Tierra Del Este Unit Ninety Five

City Plan Commission — May 8, 2025

CASE NUMBER/TYPE: SUSU25-00029 – Major Combination
CASE MANAGER: Alex Alejandre, (915) 212-1642, AlejandreAX@elpasotexas.gov
PROPERTY OWNER: Ranchos Real IV, Ltd.
REPRESENTATIVE: Conde, Inc.
LOCATION: South of Edgemere Blvd. and East of Tim Floyd St. (Extraterritorial Jurisdiction (ETJ))
PROPERTY AREA: 106.89 acres
VESTED RIGHTS STATUS: Vested (August 2008)
PARK FEES: Park Fees Not Required
EXCEPTIONS/MODIFICATIONS: Yes, see following section
ZONING DISTRICT(S): N/A property lies within ETJ

PRELIMINARY PLAT

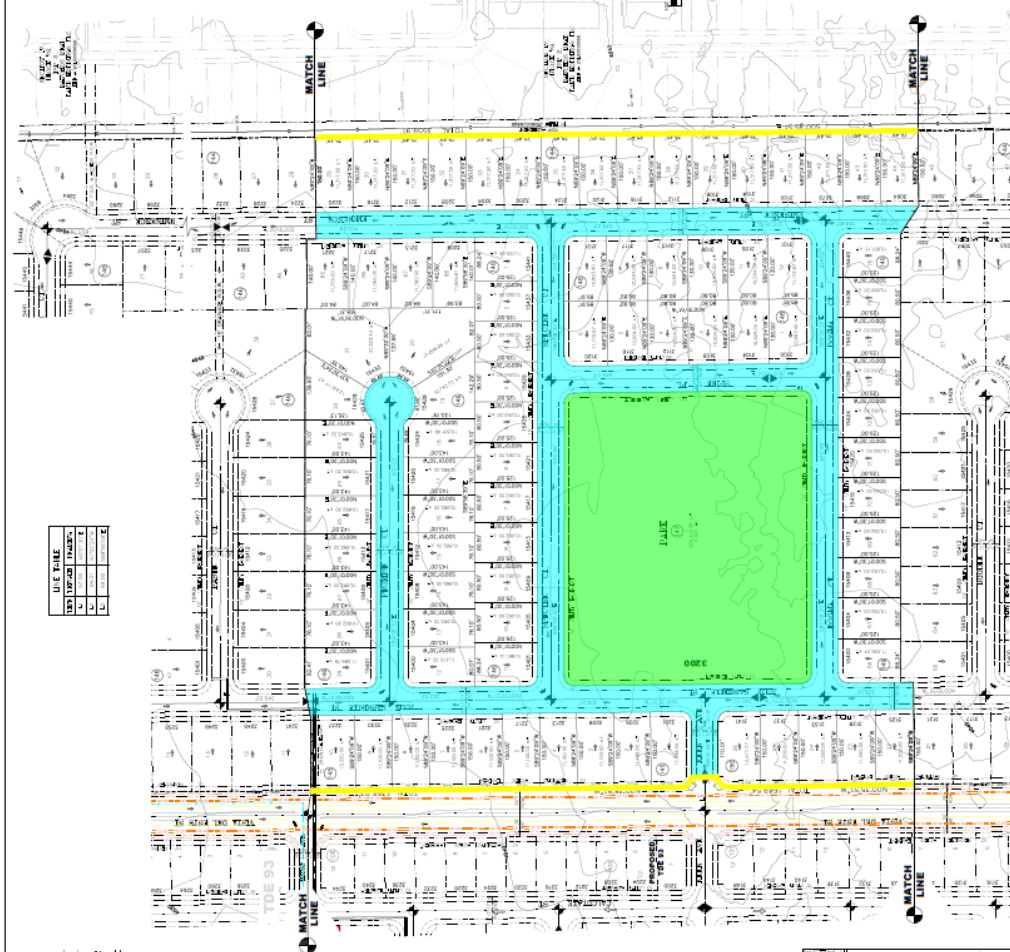
1. Provide subdivision improvement plans.
2. Provide print-out of the mathematical closure report is ok.
3. Coordinate the watershed area in acres and the Drainage I, II, III, and IV with the offsite areas in the subdivision in process “Tierra del Este Unit 93”, the proposed ponds for this subdivision shall have enough capacity to hold the developed runoff for a designated 100-yr. storm event.
4. Verify the Drainage report for “the two proposed retention basins located west of Vista del Este Dr. in the proposed Tierra del Este Unit 95 subdivision” instead of 93, please clarify.

El Paso Central Appraisal District

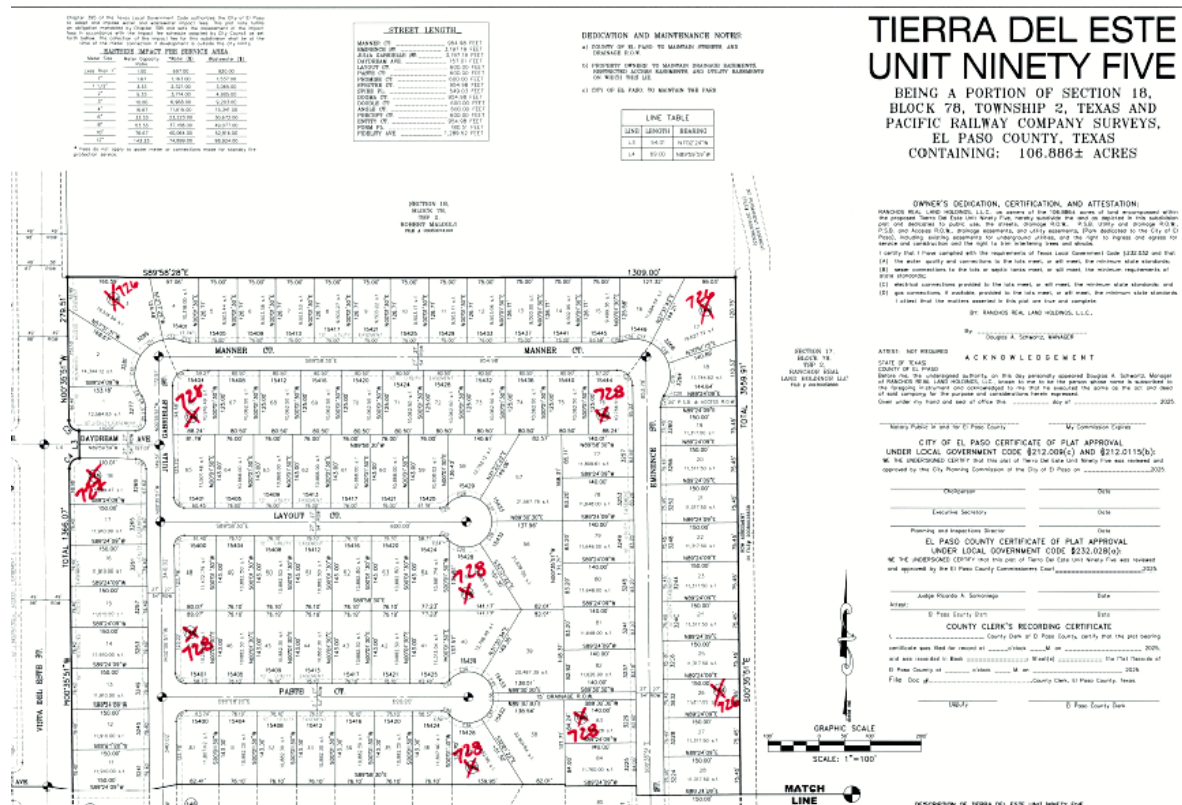
Please see below map for comments for Tierra del Este #95 from Central Appraisal.
